Subject: # 08-12 Drainfield Loading Rates

Florida Onsite Wastewater Association (FOWA)

FOWA Soil Loading Rate Proposal Impact

64E-6.009(3)

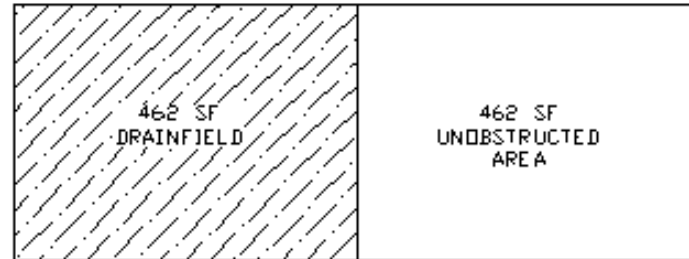
(d) Where the soil material underlying a mound system is of a similar slightly limited textural material as that used in system construction, the mound drainfield size shall be based on estimated sewage flows as specified in 64E-6.008, F.A.C., Table I and upon the quality of fill material utilized in the mound system. When estimated sewage flows are calculated to be less than 200 gallons per day, specifications for system design shall be based on a minimum flow of 200 gallons per day. Maximum sewage loading rates for soils used in mound construction shall be in compliance with the following:

Fill Material	Maximum Sewage Loading Rate to Mound Drain Trench Bottom Surface in gallons per square foot per day	Maximum Sewage Loading Rate to Mound Absorption Bed Bottom Surface in gallons per square foot per day
Sand; Coarse Sand; Loamy Coarse Sand	1.00 <u>0.80</u>	0.75 <u>0.60</u>
Fine Sand	0.80	0.65 <u>0.60</u>
Sandy Loam; Coarse Sandy Loam; Loamy Sand	0.65	0.40

**FOWA Proposal –
Decrease all loading rates
by 20%**

0.80	0.60
0.64	0.52
0.52	0.32

Example: 3 Bedroom System - Mound in a Bed Configuration with Fine Sand Fill.

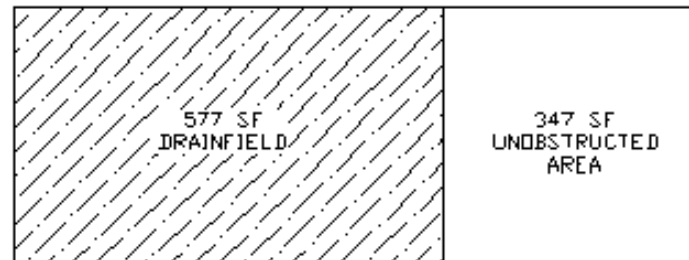
Design Flow = 300 gal/day, Sewage Loading Rate = 0.65 gal/day/sf. Drainfield area = 462 sf. Total unobstructed "footprint" is 924 sf (2.0 times required drainfield area).

A. Decrease sewage loading rates by 20% (use 0.52 gal/day/sf instead of 0.65 gal/day/sf)

B. Decrease required suitable unobstructed area by 20% (total area must be 1.6 times the required drainfield area instead of 2.0 times the area)

RESULT: Initial drainfield area is increased by 25% and total footprint remains constant
